STS-3 ELECTRICAL BOX ASSY. P/N 54445 REV B

Air Techniques Inc. WS-0046 Rev. A 1-19-04

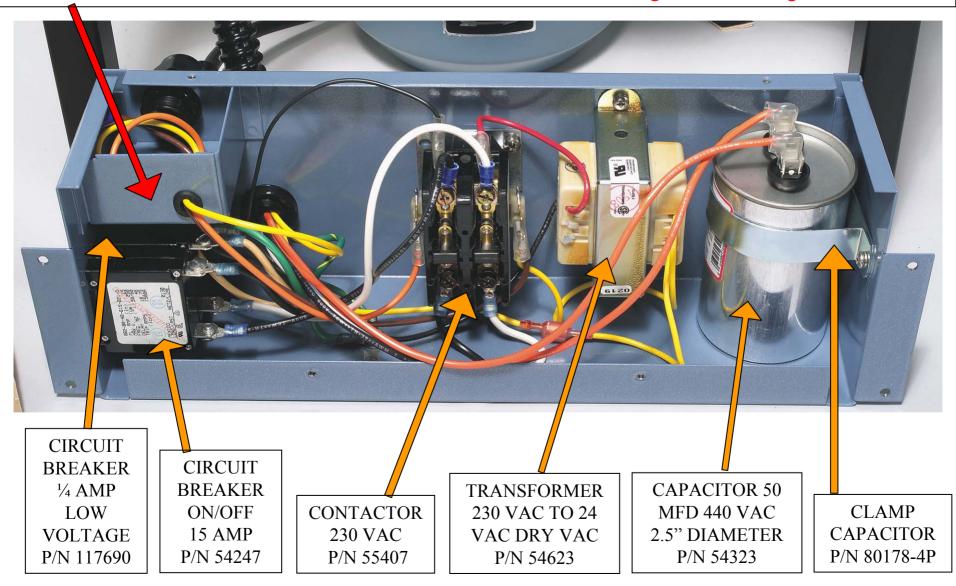
NOTE: **New UL requirement** – 24 VAC remote wire connections are now located in the electrical box in its own enclosure. Electrician will have to run remote wires into the low voltage section through the strain relief
